CASE SUMMARY
Design Adjustment Committee
DAC-11-125

Design Adjustment
January 15, 2025

<i>Address</i>	4504 & 4632 Still Meadow Drive	
<i>Acreage</i>	Approximately 27.01 acres	
<i>Request</i>	Request for design adjustments to exceed the maximum length for private driveways	
<i>Consultants/ Agents</i>	Cindee Wolf P.O Box 7221 Wilmington, NC 28406	(910) 620-2374 cwolf@lobodemar.biz
<i>Property Owner</i>	CPGPI Still Meadow, LLC 1330 Saint Mary's Road, Suite 100 Raleigh, NC 27605	(919) 803-6736 jack.dunn@cpgre.com
<i>Design Adjustment Committee Action</i>	1/15/25; Scheduled for Evidentiary Hearing

Design Adjustment Narrative for Still Meadow Village Apartments Infill

Figure 1. Exhibit

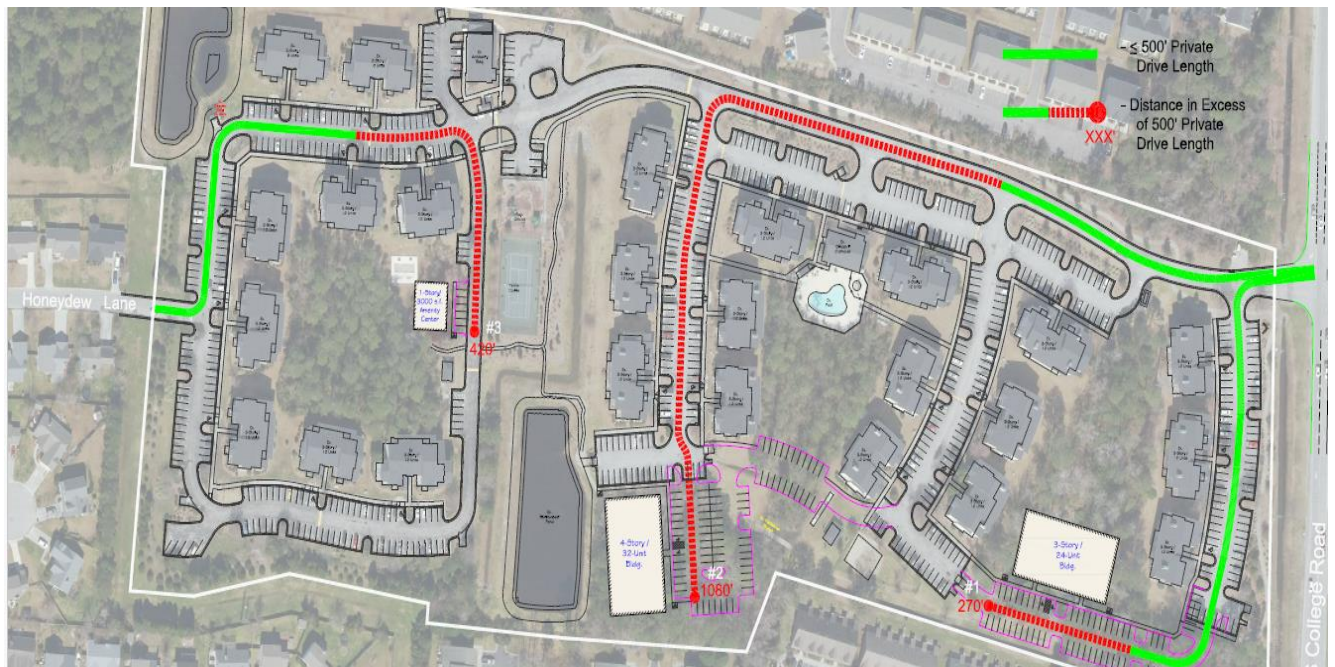
1. The site contains 27.01 acres, and is located within an existing MD-10, Residential District.
2. The applicant proposes to exceed the maximum length allowed for three private driveways.

3. The applicant is proposing to extend two private driveways from S. College Road. The maximum distance of each driveway would be 770 feet and 1,080 feet, respectively.

4. The applicant is also proposing to extend a private driveway from Honeydew Lane. The maximum distance would be 820 feet.
5. The applicant requests relief from the Technical Standards & Specifications Manual (TSSM).

6. The Technical Standards & Specifications Manual (TSSM) specifies minimum standards for a private driveway:
 - If the private driveway accesses a through street, the total length shall not exceed five hundred linear feet (500 l.f.).

- Lengths are measured from the curbline of the intersecting through street to the bottom of the cul-de-sac bulb, or end of roadway, to the furthestmost end of the parking lot or area which the private driveway serves.

Exhibit for DAC Waiver Requests

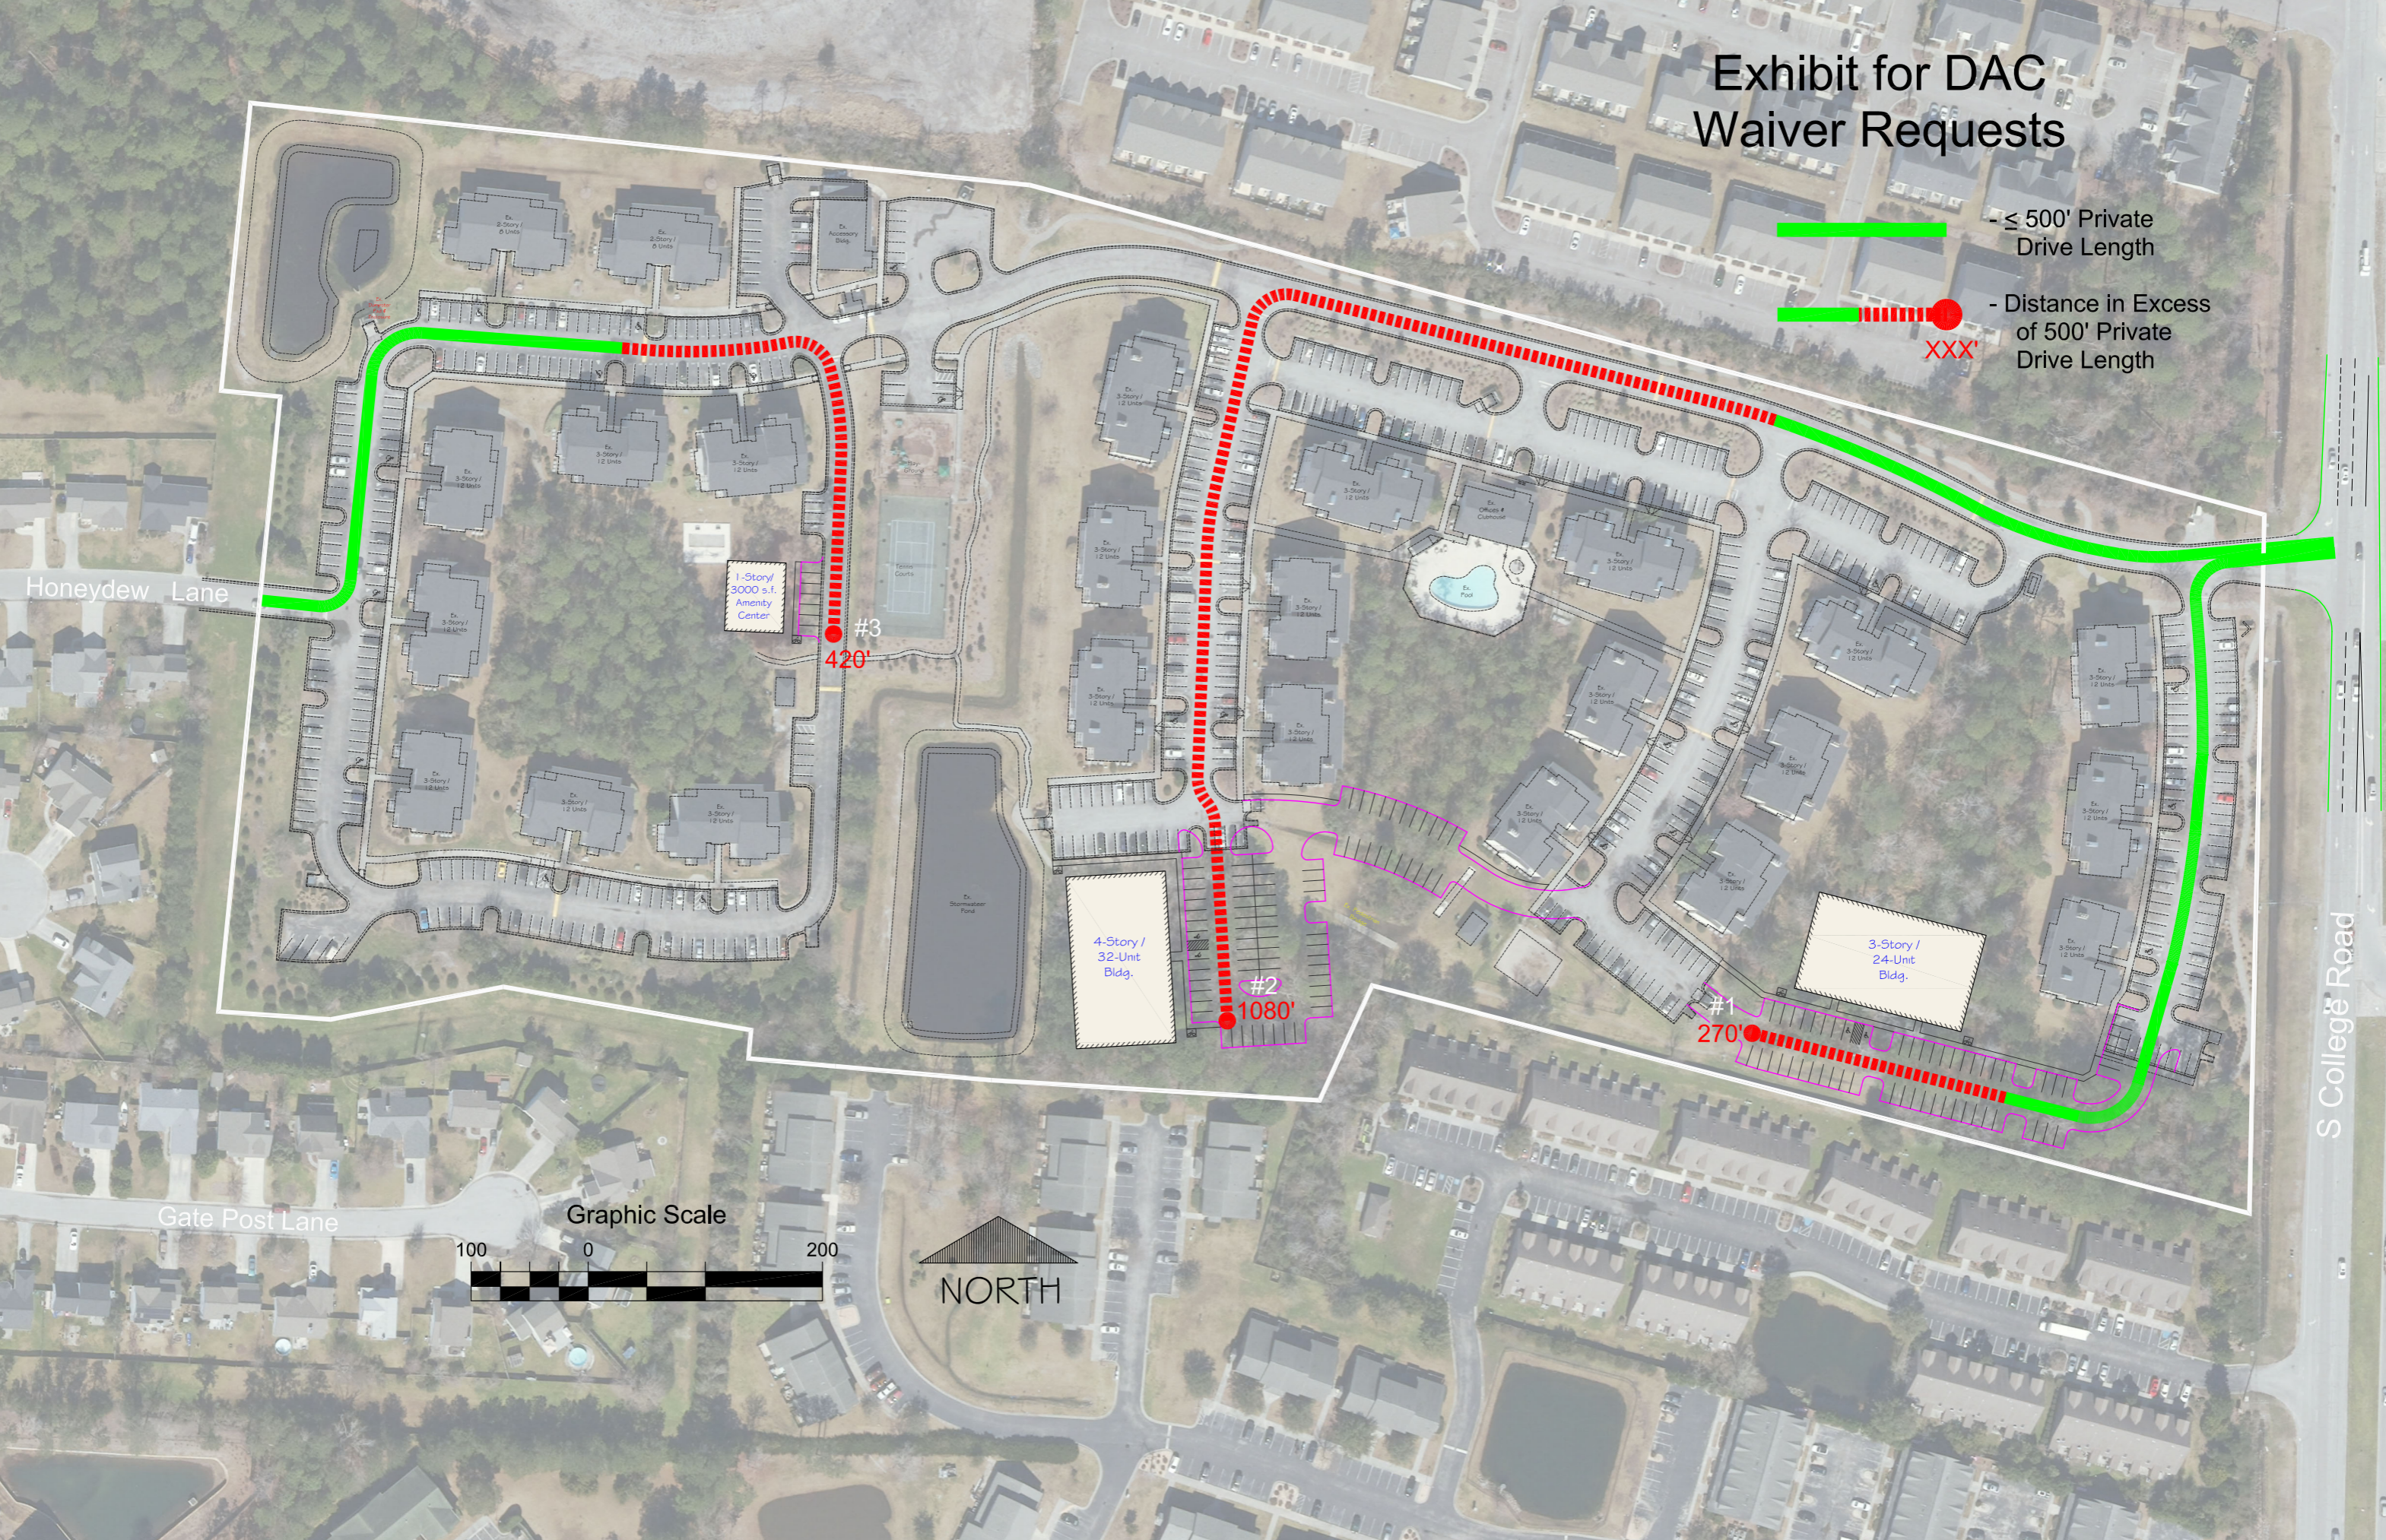
The private drives accessing the proposed new structures exceed the maximum distance of five-hundred (500) linear feet from a through street. Waivers requested for the maximum distance include:

1. Allowance for a private drive to extend a maximum distance of 770', from S. College Road.
 - a. The subject building will have a sprinkler system.
 - b. The building is accessible from dual directions.
 - c. All travel lanes are a minimum of 20' in width, and interior curves have a minimum radius of 20'.
2. Allowance for a private drive to extend a maximum distance of 1080', from S. College Road.
 - a. The subject building will have a sprinkler system.
 - b. The building is accessible from dual directions.
 - c. All travel lanes are a minimum of 20' in width, and interior curves have a minimum radius of 20'.
 - d. All points within the parking area are accessible from dual directions.
3. Allowance for a private drive to extend a maximum distance of 820', from Honeydew Lane.

- Not increase congestion or compromise safety. Traffic within the private drives will be limited to the traverse of the residents and guests of the apartment complex.
- Not be contrary to the public interest, nor materially endanger the overall public safety because all proposed improvements continue to meet emergency services criteria.
- Conform with adopted comprehensive plans and other applicable plans in that development is promoted for under-utilized land where existing urban services are available. Multi-dwelling residential projects can accommodate that growth strategy.
